Bulletin Type.....: Safety Recall

Bulletin No.....: TS-S123 (Rev01)

**Bulletin Name.....: Tag Axle Air Bellow Protection
Cover**

Subject: Replacement of bended or deformed tag axle air bellow protection cover.

Figure - 3: Removal of existing air bellow protection covers of tag axle

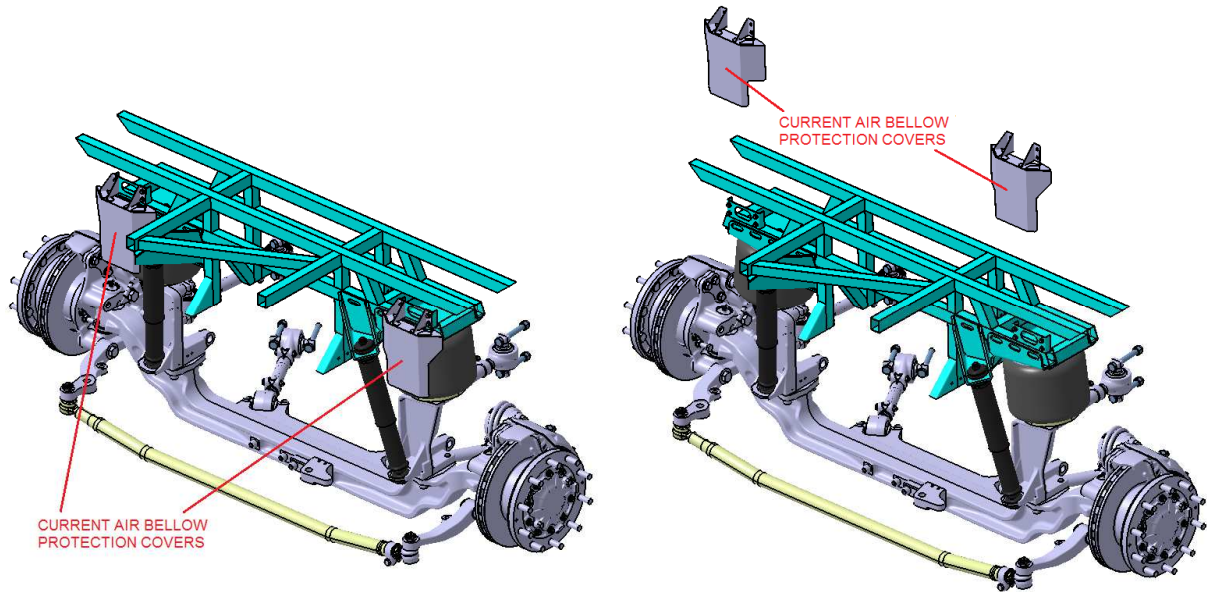
If current air bellow protection covers still exist on the vehicle, remove them by loosening the bolts, (**See Figure-3**)

Figure – 4

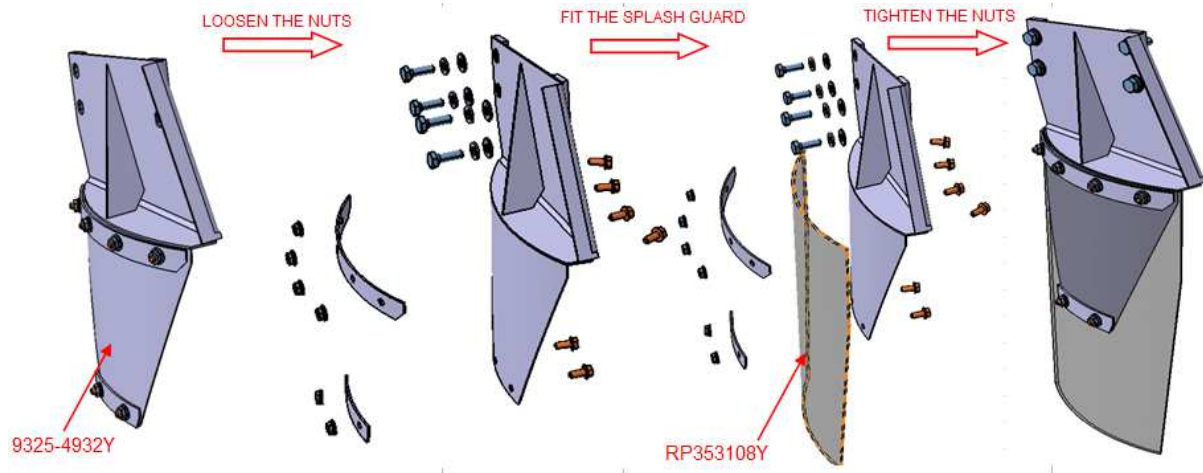
Note: Same subassembly process is also valid for the air bellow protection cover at right side

Figure - 5: Fix the protection cover at left side by the bolts given in DETAIL -A (tightening torque is 8 lbft).

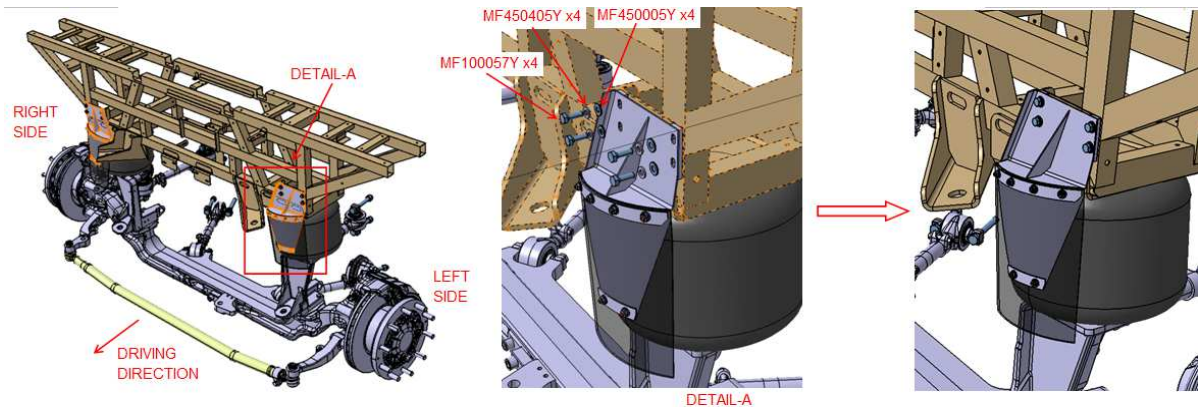
Install both air bellow protection covers to the vehicle, see in **Figure-5** and **Figure-6**.
